Stage 1 Road Safety Audit Report (Feasibility)

**Littlehampton Phase 5 Spine Road
Chainages 0-180m & 700 -1020m
Proposed new residential
development**

Report Title: Stage 1 (Feasibility) Road Safety Audit

Stage 1 RSA – Road Safety Audit Response Report

13. Identified Road Safety Audit Matters location plans

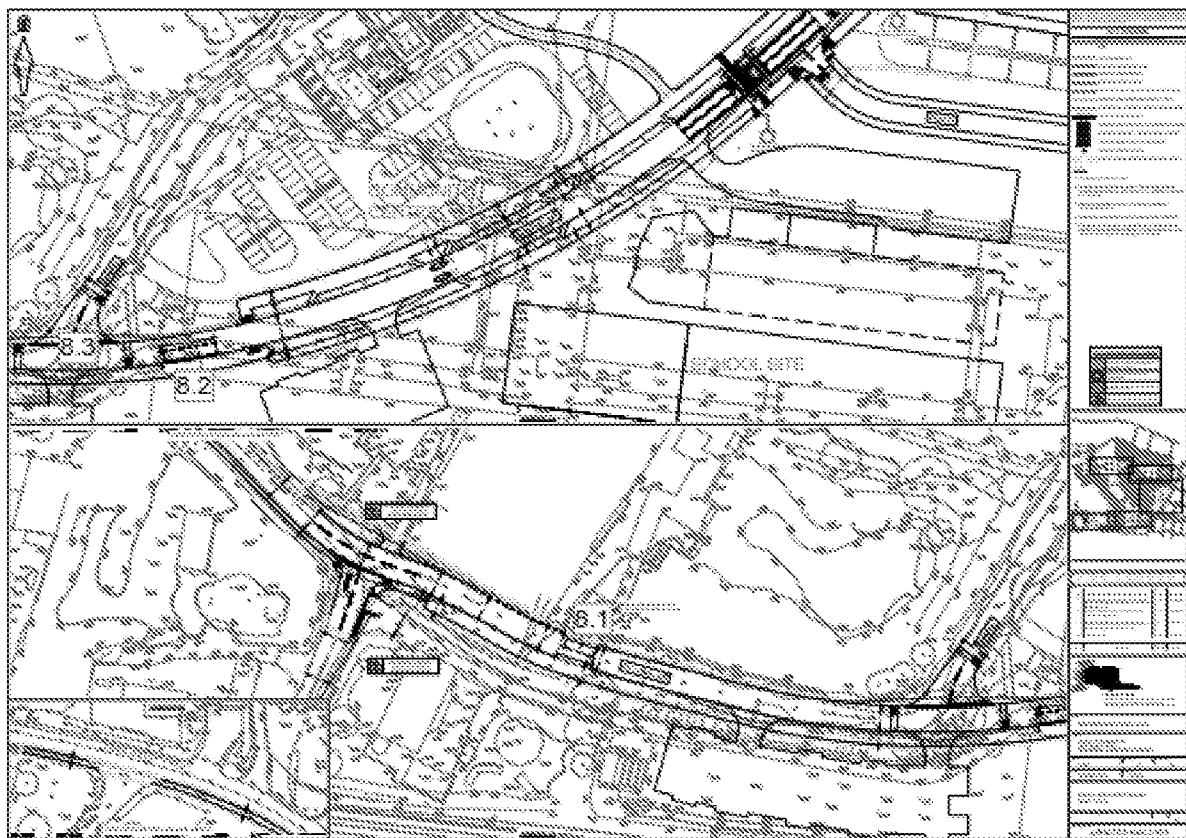
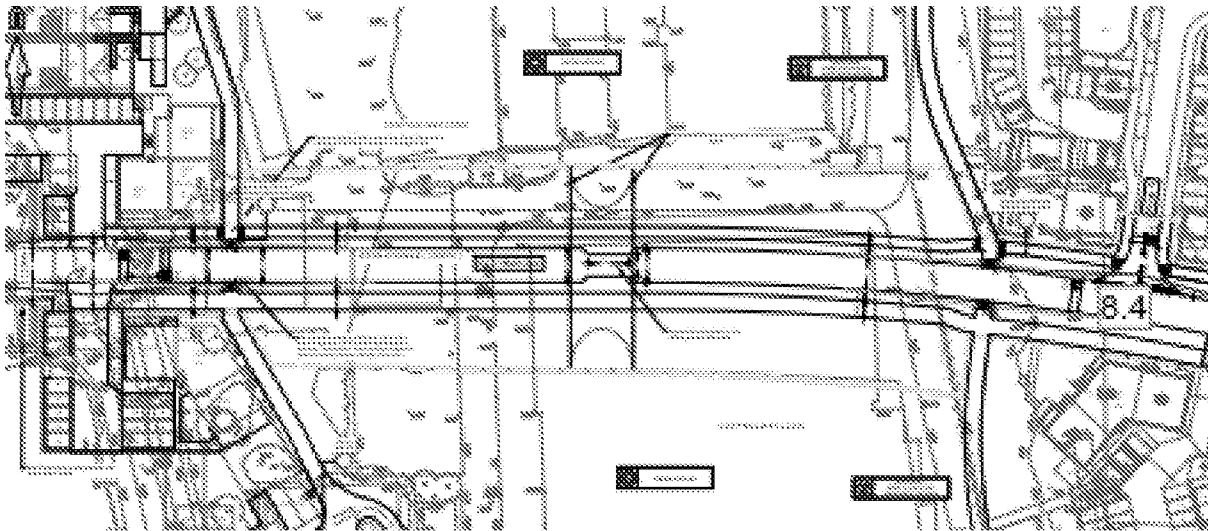
8.1 *Problem* (Item A1.8)	
Location:	Private access Chainage 970
Summary:	A carriageway narrowing feature is detailed adjacent to a private vehicle access, check access maintained
There is a carriageway narrowing feature detailed adjacent to a private driveway access. Check vehicle tracking to ensure vehicles can use the access safely	
TYPE OF CONFLICT/COLLISION	
Vehicles unable to use vehicle access safely	
RECOMMENDATION	
Carry out vehicle swept path analysis to ensure access can be used safely

8.2 *Problem* (Item A3.1)	
Location:	Spine Road, Junction Road 11 Chainage 860.00
Summary:	Bus stop located on approach to side road junction
There is a bus stop located on the approach to the side road junction with Road 11 at Chainage 860.00. This will result on any vehicles overtaking a stationary bus approaching the junction on the wrong side of the road risking a head on collision with a left turning vehicle out of the side road. Relocate bus stop	
TYPE OF CONFLICT/COLLISION	
Head on collisions at junction	
RECOMMENDATION	
Relocate bus stop away from junction

8.3 *Problem* (Item A4.2)	
Location:	Spine Road junction with Road 11
Summary:	No pedestrian footway facilities at junction
A side road junction is detailed without any pedestrian footway facilities. Check to ensure if any pedestrian facilities are required at junction and provide if required	
TYPE OF CONFLICT/COLLISION	
Pedestrians having to walk over verges at junction	
RECOMMENDATION	
Check if pedestrian facilities are required and provide if necessary

8.4 *Problem* (Item A4.2)	
Location:	Spine Road junction with Road 4
Summary:	No facility to enable cyclists to access exit from road 4 and join shared use path on opposite side of road
There is a side road junction detailed without any facility to enable cyclists to joint /exit from the shared use path to Road 4. Provide facility to enable cyclists to access exit from shared use path to join side road 4	
TYPE OF CONFLICT/COLLISION	
Cyclists unable to access /exit from path at junction	
RECOMMENDATION	
Provide facility to enable cyclists to access /exit path at junction

Item	Problem	Recommendation	Designer's Response	Overseeing Organisation Response	Agreed RSA Action
8.1	Location: Private access chainage 970 Summary: A carriageway narrowing is detailed adjacent to a private vehicles access. Check access is maintained. There is a carriageway narrowing feature detailed adjacent to a private driveway access. Check vehicle tracking to ensure vehicles can use the access safely. Type of Conflict/Collision: Vehicles unable to use vehicles access safely.	Carry out vehicle swept path analysis to ensure access can be used safely.	Accepted. A vehicles swept path analysis has been carried out for the nearest access to the road narrowing (worst case scenario). The tracking shows cars can still use the access safely with the narrowing. The narrowing restricts the road width locally to 4.1m, which allows two cars to pass each other. Giveaway marking has also been added to give priority to buses and cars travelling westbound.

Item	Problem	Recommendation	Designer's Response	Overseeing Organisation Response	Agreed RSA Action
8.2	Location: Spine Road, Junction Road 11 Chainage 860.00 Summary: Bus stop located on approach to side road junction. There is a bus stop located on the approach to the side road junction with Road 11 at Chainage 860.00. This will result on any vehicles overtaking a stationary bus approaching the junction on the wrong side of the road risking a head on collision with a left turning vehicle out of the side road. Relocate bus stop. Type of Conflict/Collision: Head on collisions at junction.	Relocate bus stop away from junction.	Accepted. The bus stop has been relocated further north, approximately in the middle of the proposed school access and parking area to the south of the community centre.

8.3	Location: Spine Road junction with Road 11 Summary: No pedestrian footway facilities at junction. A side road junction is detailed without any pedestrian footway facilities. Check to ensure if any pedestrian facilities are required at junction and provide if required. Type of Conflict/Collision: Pedestrians having to walk over verges at junction.	Check if pedestrian facilities are required and provide if necessary.	Not accepted. No pedestrian facilities are required along Road 11, and therefore no footways have been added.

Item	Problem	Recommendation	Designer's Response	Overseeing Organisation Response	Agreed RSA Action
8.4	Location: Spine Road junction with Road 4 Summary: No facility to enable cyclists to access exit from Road 4 and join shared use path on opposite side of road. There is a side road junction detailed without any facility to enable cyclists to join/exit from the shared use path to Road 4. Provide facility to enable cyclists to access exit from shared use path to join side Road 4. Type of Conflict/Collision: Cyclists unable to access / exit path at junction.	Provide facility to enable cyclists to access / exit path at junction.	Accepted. A 3m wide cycle facility has been added opposite the junction to aid cyclists movements between Road 4 and the shared-use footpath on the other side.
